**Re: Epiq Lennox (Pacific Pines Estate), Lennox Head - MP 07\_0026 MOD 7**  
**Response to Submissions & Additional Information**

Reference is made to the Department of Planning & Environment (**DPE**) letter dated 12 May 2022, in relation to the proposed Modification to MO07\_0026, for Lot 5 DP 1239938 within the Epiq Estate Lennox Head.

**Re: Epiq Lennox (Pacific Pines Estate), Lennox Head - MP 07\_0026 MOD 7  
Response to Submissions & Additional Information**

**Site Plan**  
5551.1S.02.CC

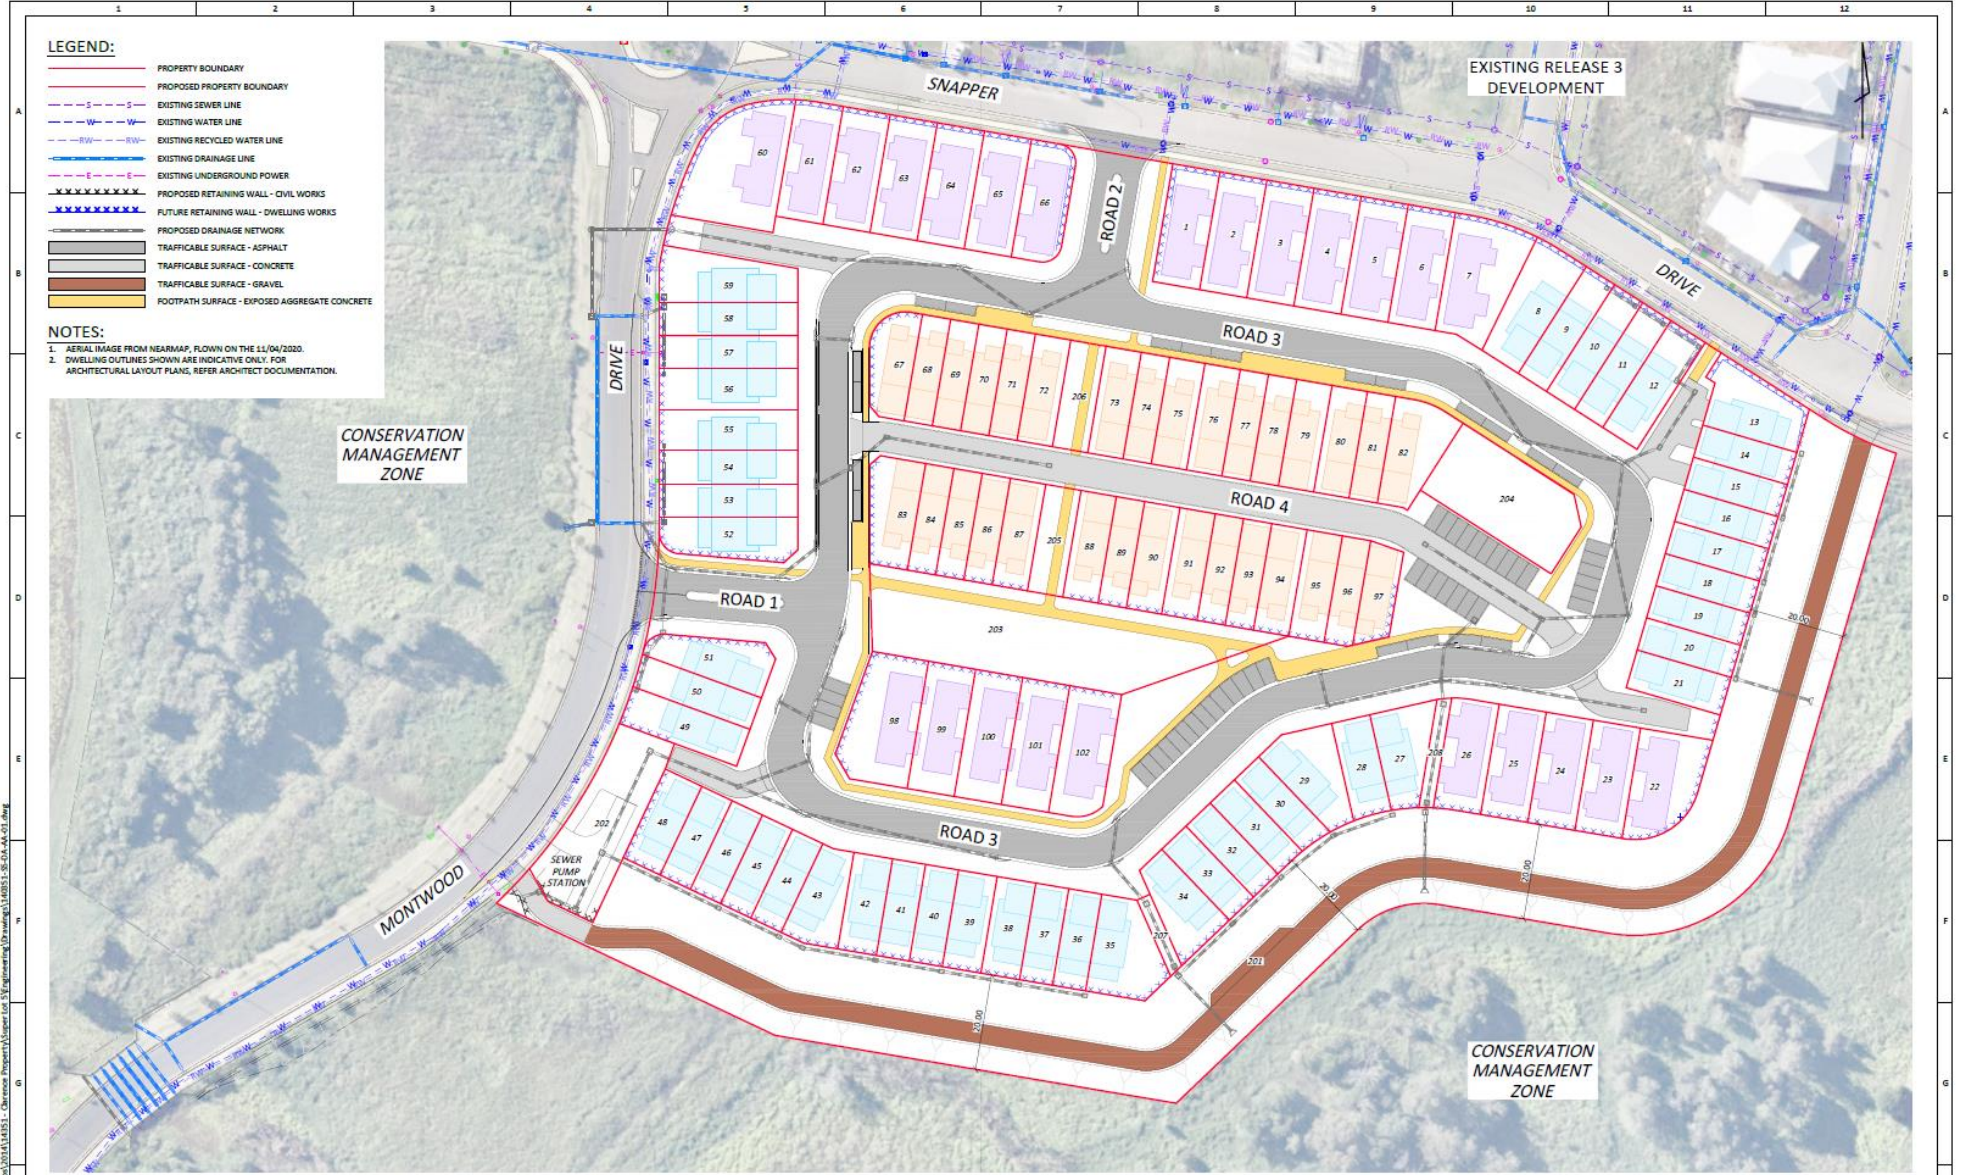
*“Clarification whether the 20m buffer provided to the conservation zone, including the 5m vegetation landscaping strip, will alter the bushfire threat to the site and recommendations of the submitted Bushfire Report (dated 12 August 2018). It is noted that the Site Plan provided to the bushfire consultant (Attachment A to the letter dated 7 February 2022 prepared by Bushfire Certifiers) does not identify any landscaping in the 20m buffer area.” (NDC Email dated 27<sup>th</sup> May 2022)*

This office has reviewed the attached site plan Drawing No. 5551.1S.02.CC (see Attachment A) for the residential subdivision of Lot 5 DP 1239938, Montwood Drive Lennox Head against the previous correspondence prepared by this office dated 7<sup>th</sup> February 2022 and the current Bush Fire Safety Authority (BFSa) dated 23 July 2020 (see Attachment B).

The review of the subject site plan is limited to the assessment of the proposed 5m deep landscape buffer located directly adjacent to south and southeast boundary on the bushfire hazard side of the 20m wide conservation zone.

The plan shows the closest building envelope denoted No. 22 as being adjacent to the residential allotment boundary, with 15m of open space within the conservation zone inclusive of the 4m wide accessway. The 5m landscaped ‘mosquito proof planting’ is located adjacent to the 15m cleared area.

It is suggested the recommendation be slightly amended to require the 5m buffer planting to consist of high-moisture rainforest species. This will not compromise the maximum 29kW/m<sup>2</sup> threshold for compliance with Table A1.12.3 of Planning for Bushfire Protection 2019. It is also noted the Vegetation Management Plan will need to ensure the plantings are managed so as an unobstructed height of 4m above the accessway is maintained to comply with Condition No. 5 of the Bush Fire Safety Authority dated 23<sup>rd</sup> July 2020.
